REMARKS/ARGUMENTS

In this Voluntary Amendment, a number of amendments are being made to the description, figures and claims of the application as filed. The Applicant submits that amendments to the description and the figures are minor and do not add any new matter. The amendments to the claims have been made to better recite the invention and also do not add new matter.

Int. Appl. No.: PCT/US02/15387
U.S. Appl. No.: 10/712,059
Response dated: October 26, 2005

FIG. 1a

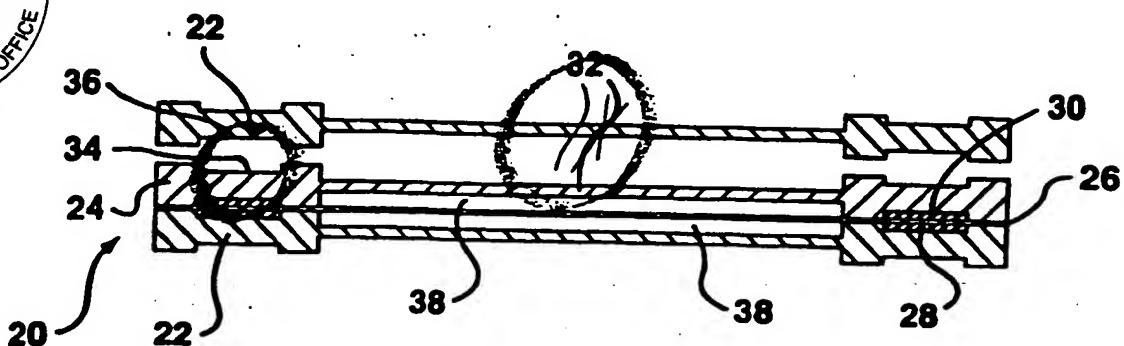
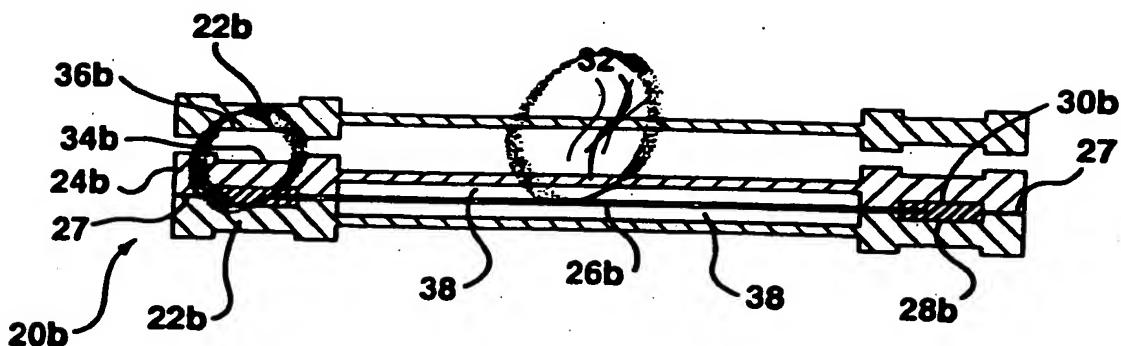
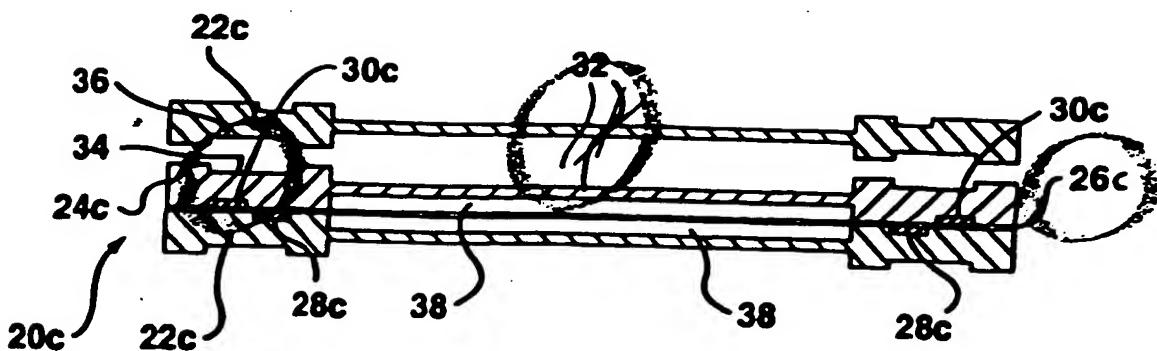
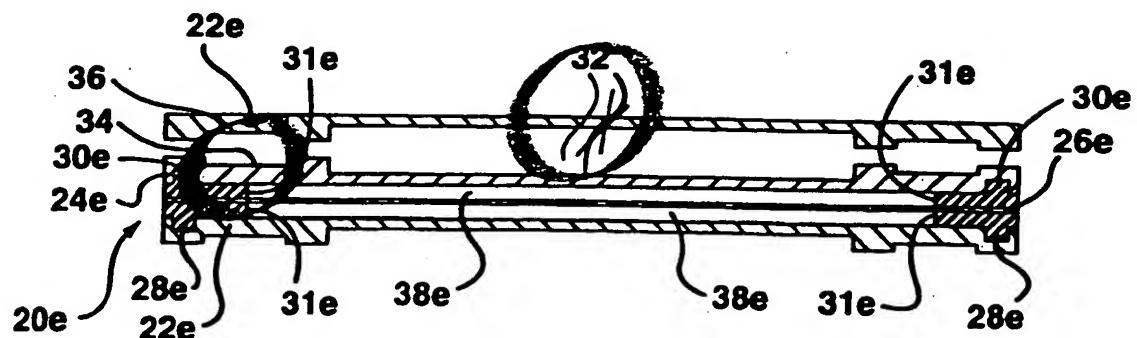
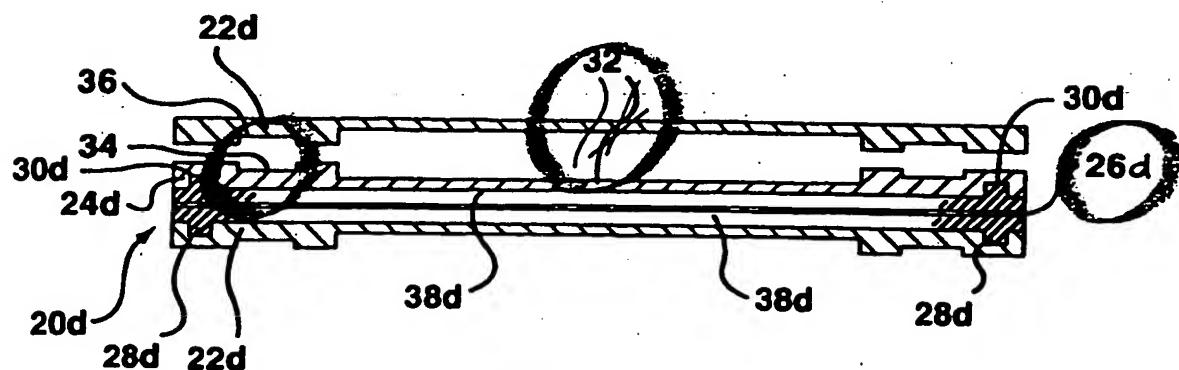
With respect to the drawings, amendments are being made to Figures 1a-e, 2, 7-12, and 17. In Figures 1 and 2, the amendments to the lead lines are intended merely to ensure that these drawings are wholly consistent with the specification and to aid in understanding the drawings. In Figure 7, the connection apertures have been labeled

FIG. 7

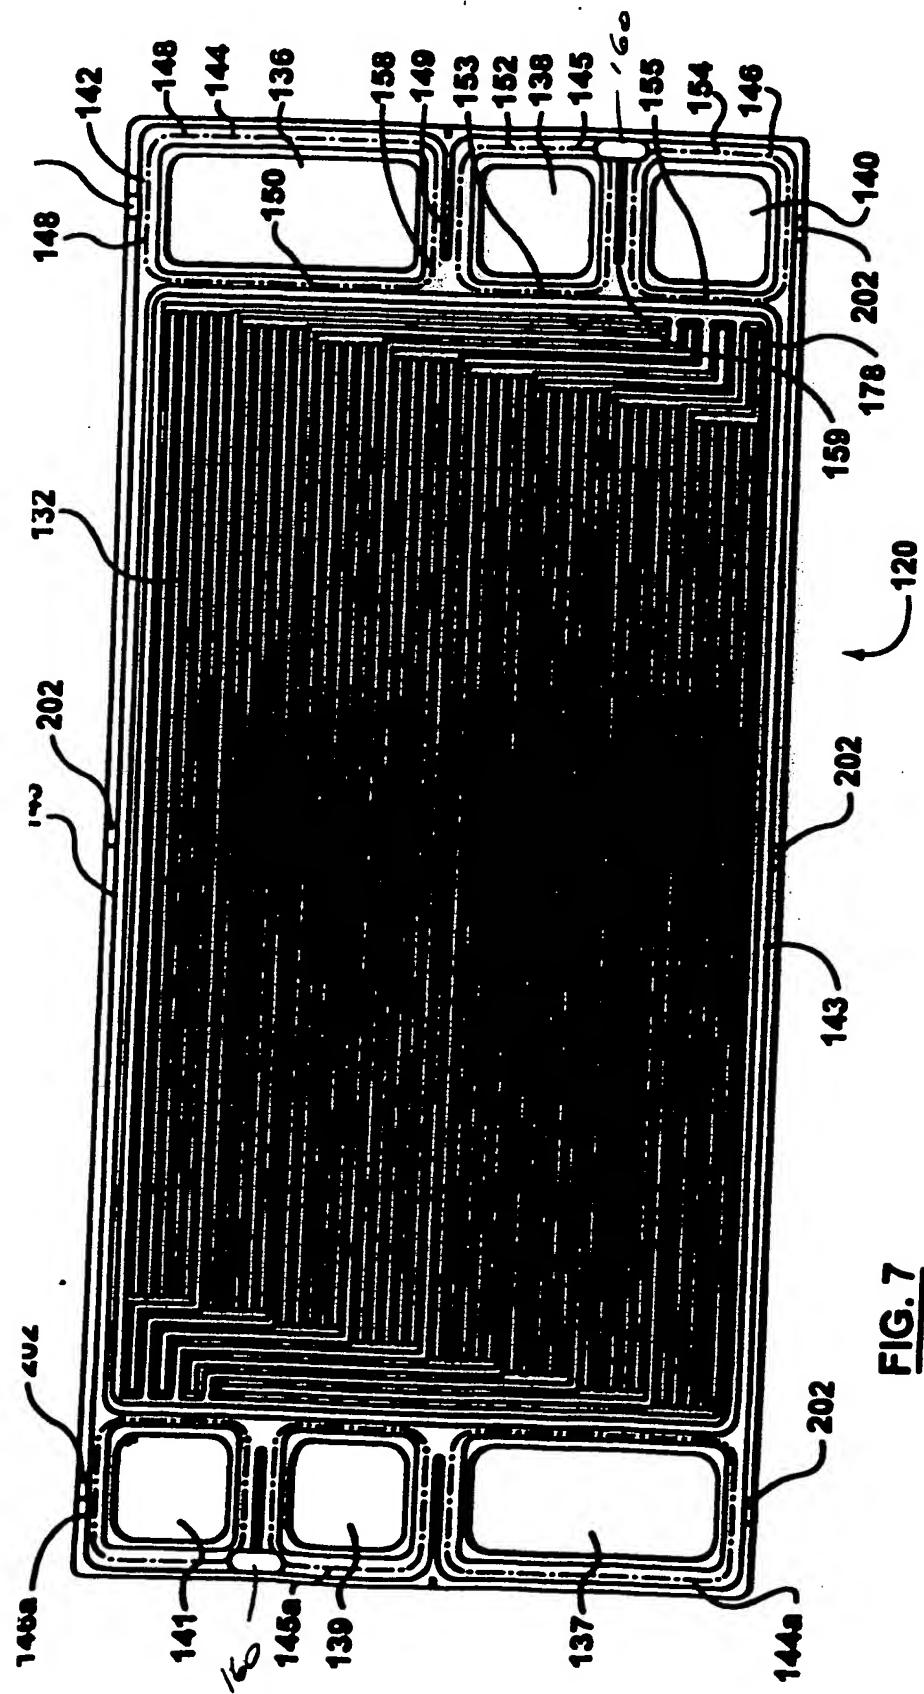
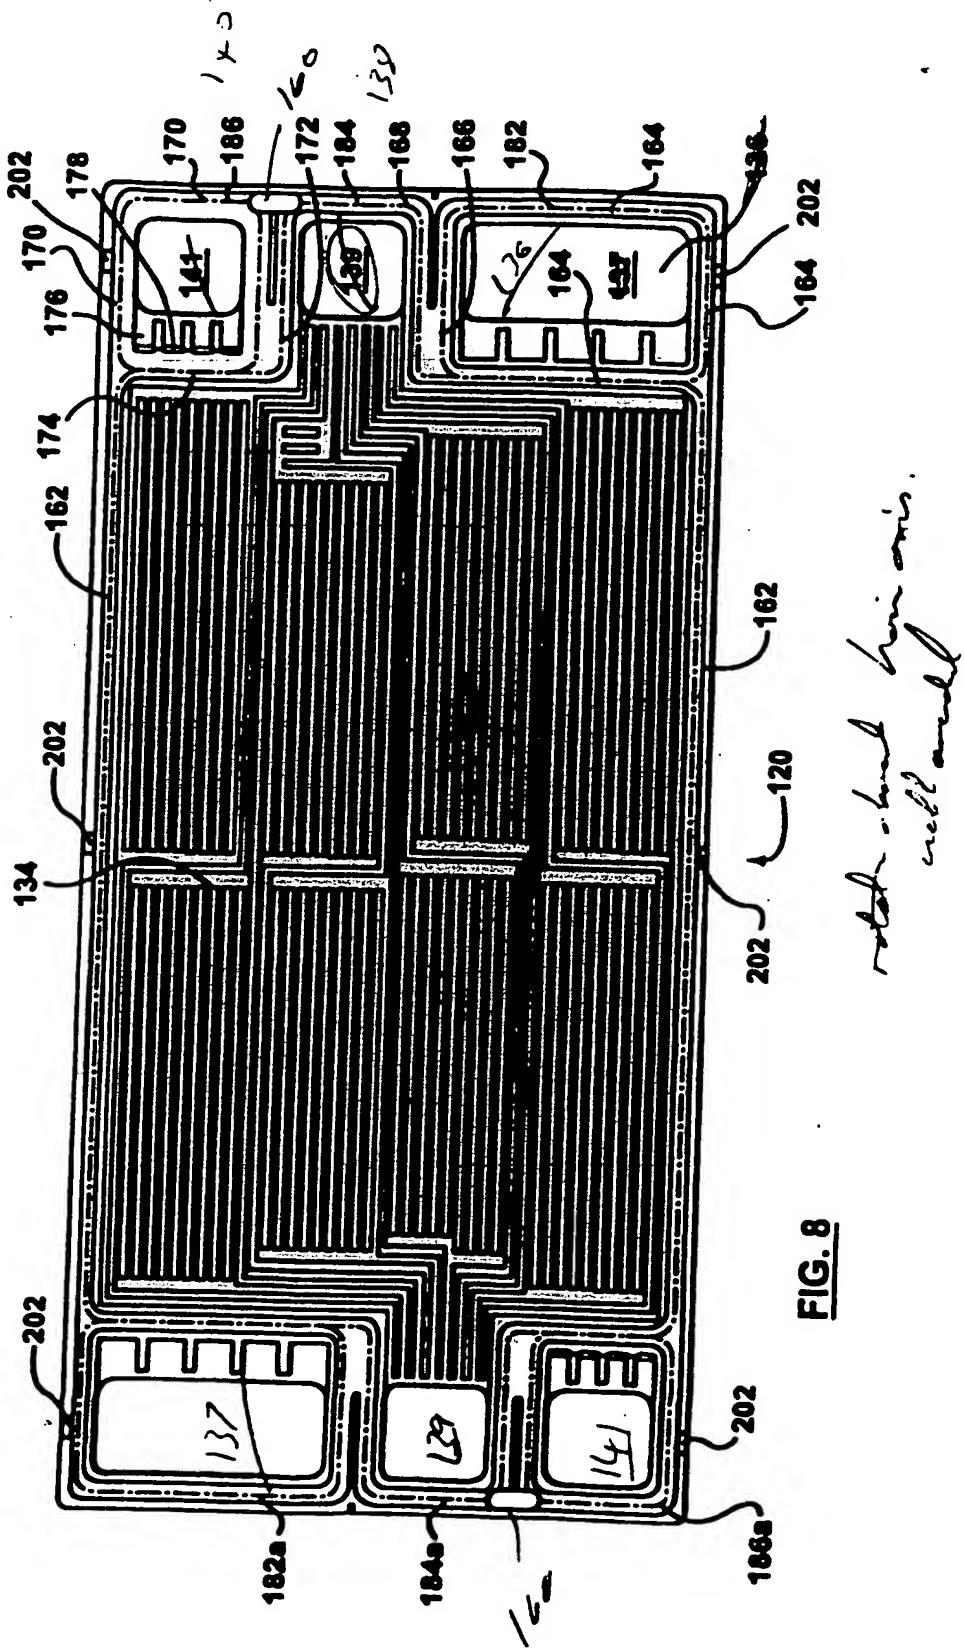
with reference numeral 160. In Figure 8, for consistency with Figure 7, the references 137, 139 and 141 now denote ports on the left hand side, while references 136, 138 and 140 denote ports on the right hand side. In Figure 9, the connection apertures have been labeled with reference numeral 160. In Figure 10, the reference numerals 182', 184' and 186' are, in effect, being switched with the reference numerals 182a', 184a' and 186a'. In Figure 11, at the right hand side reference numeral 160e has been amended to read 160ae and the reference 160e added on the left hand side; at the top 132 has been corrected to 192. These amendments are simply intended to ensure consistent use with the reference numerals used in the Figures and the description and for clarity in the drawings.
